CITY OF MARSHFIELD

PLAN COMMISSION

Tuesday, June 21, 2016

TO: Plan Commission
FROM: Josh Miller, City Planner
DATE: June 21, 2016

Sheet Title:
LANDSCAPE PLAN

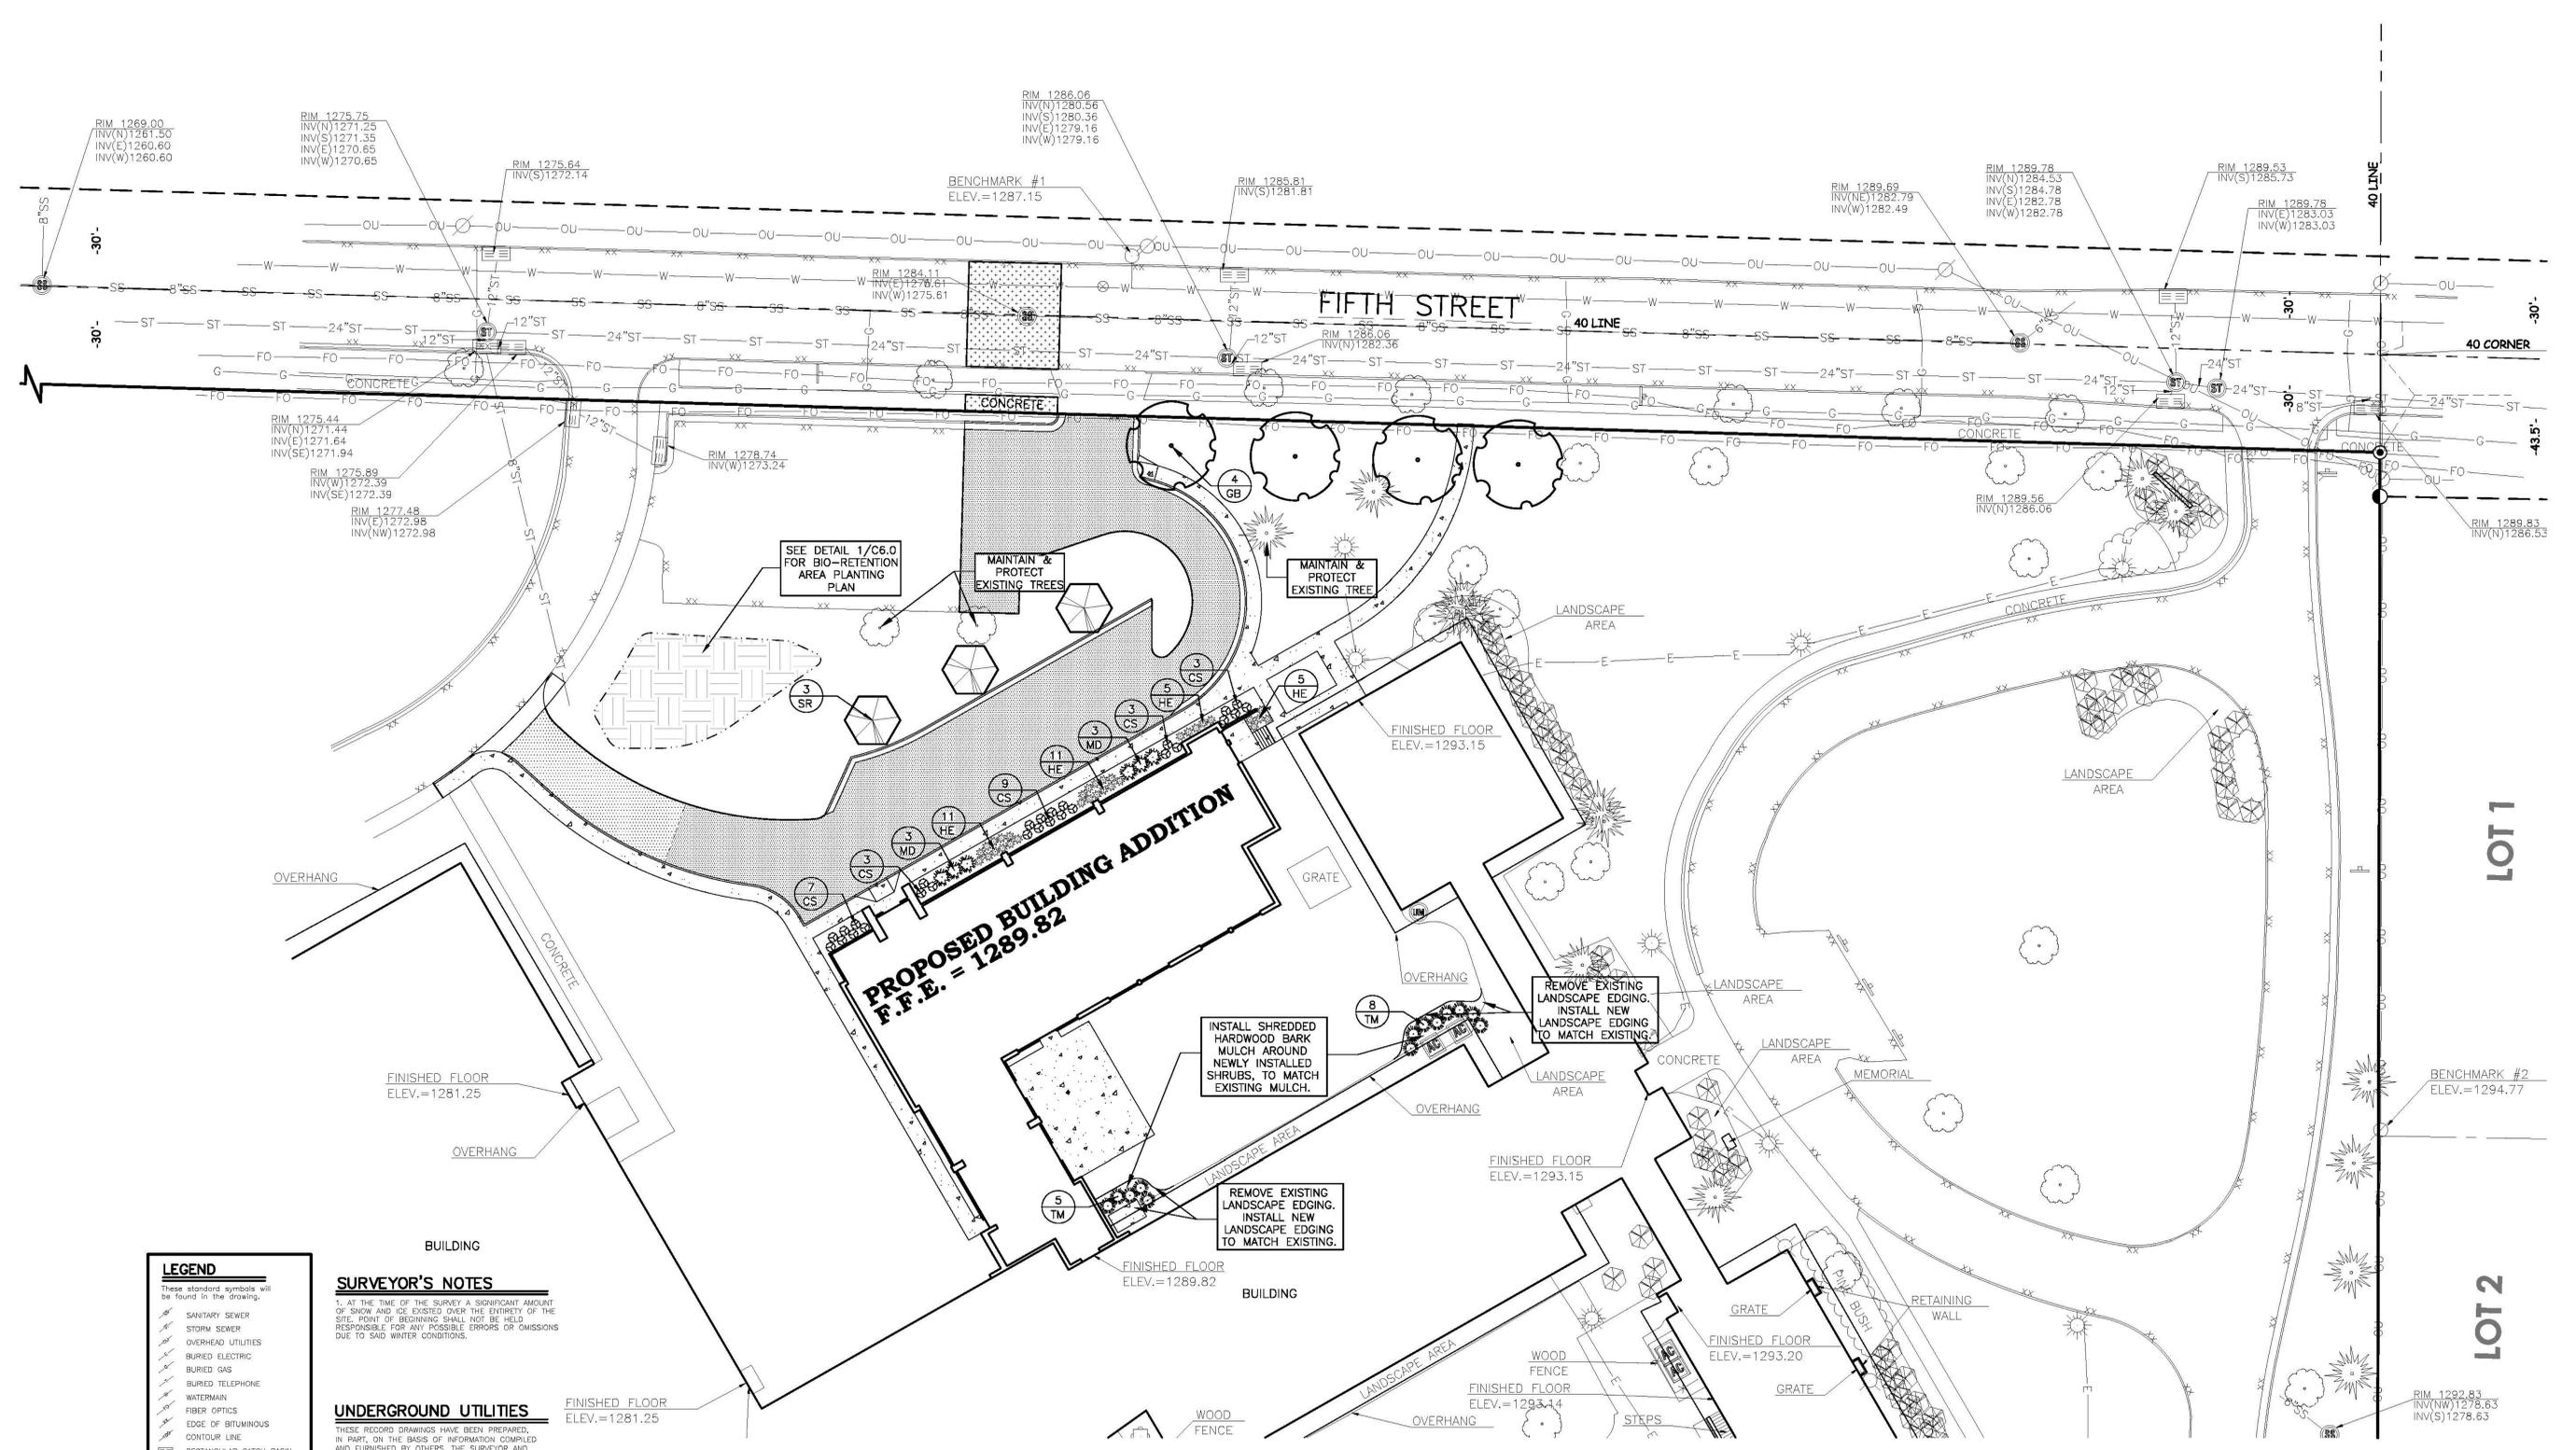
Section 18-133(2) states for every 100 linear feet of street frontage of a development lot abutting a public street, there shall be a minimum of 40 points of landscape plants installed in the "CD" Campus Development District. This development visible from the right-of-way abuts one public street including 220 feet along West 5th Street. Calculating out the minimum landscape requirements this development would be required a minimum of 88 points along West 5th Street. The submitted landscape plan shows approximately 160 points of new landscaping plus 80 points for two existing decorative trees within the right-of-way along West 5th Street for a total of 240 street landscaping points. Although it the plants are not as evenly distributed as we typically like to see due to the existing parking lot location and the location of utilities, 120 of the points would meet the location for street frontage landscape, still meeting this requirement.

Section 18-133(3) states for every 20 off-street parking stalls or 10,000 square feet of parking area including circulation and loading areas, which ever yields the greater requirement (parking stalls) there shall be a minimum of 60 points of landscape plants installed in the "CD" Campus Development District. With 9,101 square feet of paved surface, the minimum required parking landscaping for this development is 55 points. Without calculating the smaller shrubbery or perennial plantings, the submitted plan shows approximately 60 new points which is over the required minimum.

1. The site plan, landscape plan, and lighting plan for the STEM building is approved as presented, allowing minor site changes and building details to be approved administratively.
2. Any new driveway or parking areas must be hard-surfaced prior to the issuance of a certificate of occupancy.
3. All required landscaping must be installed prior to the issuance of a certificate of occupancy.
4. Final approval shall be contingent on the approval of a building permit.
5. If parking problems are identified as part of normal day to day operations of the facility, the Conditional Use Permit may be reviewed by the Plan Commission to determine if any additional on-site parking will be required.

North
Site Plan - Lighting Calc
Scale: 1" = 30'-0"

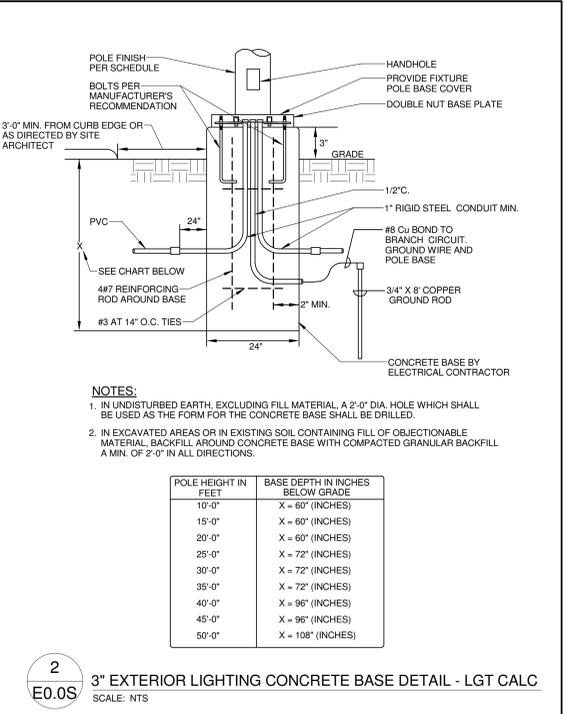
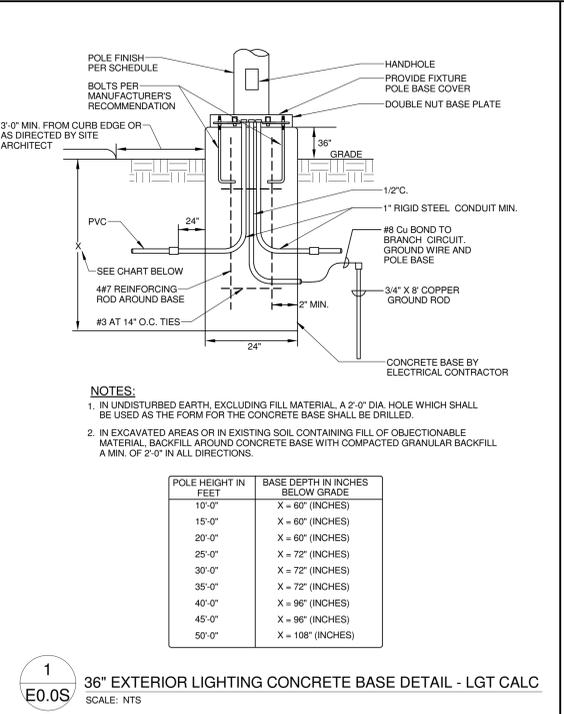
No lighting plan has been submitted at this time. Any new lighting will be required to meet the standards of Section 18-104 of the Zoning Code.
